ADMINISTRATIVE MEMORANDUM NO. 21-046

TO: Cassandra LeMasurier, Real Property Manager
VIA: David L. Recor, ICMA-CM, Director of Development Services *JG*
VIA: Jennifer Gomez, AICP, Assistant Director of Development Services *JG*
FROM: Pamela Stanton, RLA, Planner
SUBJECT: Bid Review, Pompano Library Partners, LLC, IFB 21-01, 1207 East Atlantic Blvd
DATE: May 5, 2021

Project Description

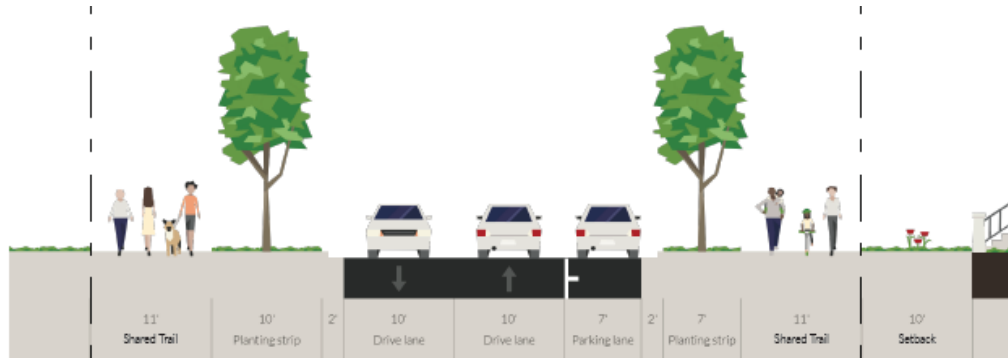
- Surface parking is prohibited along building frontages and shall be located to the side or rear of the property, pursuant to Section 155.3501.1.2.b.i. The proposed building has three frontages, East Atlantic Blvd, NE 13 Ave, and NE 1 St. The conceptual plan depicts parking along the NE 1 St frontage, and thus the plan does not comply.

- Only non-residential uses may provide parking spaces off-site, pursuant to Section 155.3501.1.2.f.i. The conceptual site plan depicts 36 on-site parking spaces. The proposal indicates 54 dwelling units are proposed. A minimum of one off-street parking space per unit or one off-street parking space per 1,000 square feet of gross floor area or fraction thereof, whichever is greater is required in the Center Sub-Area, and 1.5 spaces are required per unit in the Edge Sub-Area, and thus the plan does not comply with the regulation for the minimum number of required parking spaces.

- On-street parking along the corresponding frontage lines touching the adjacent sidewalk to the property may be used to satisfy a portion of the off-street parking requirements for all uses, except single family, pursuant to 155.3501.1.2.g. The conceptual site plan depicts 19 on-street parking spaces along the frontage lines. However, 11 of the 19 on-street parking spaces are situated as diagonal parking on NE 1 St, and are not in compliance with the Street Development Regulating Diagram for NE 1 St, shown below, which depicts parallel on-street parking spaces.

The minimum width of the perimeter landscaping strip shall always be 5 feet, regardless of development type, pursuant to Section 155.3501.J.2.a. The west perimeter of the property is shown on the conceptual site plan with a partial landscape strip, with vehicular use area abutting the property line at two locations, and thus does not comply.

The bid specifications states that a 5 foot right-of-way dedication will be required on the southern portion of the parcel fronting Atlantic Boulevard as the Broward County Traffic Ways Plan now requires a 110 foot right-of-way. The conceptual site plan does not appear to address the required land dedication.
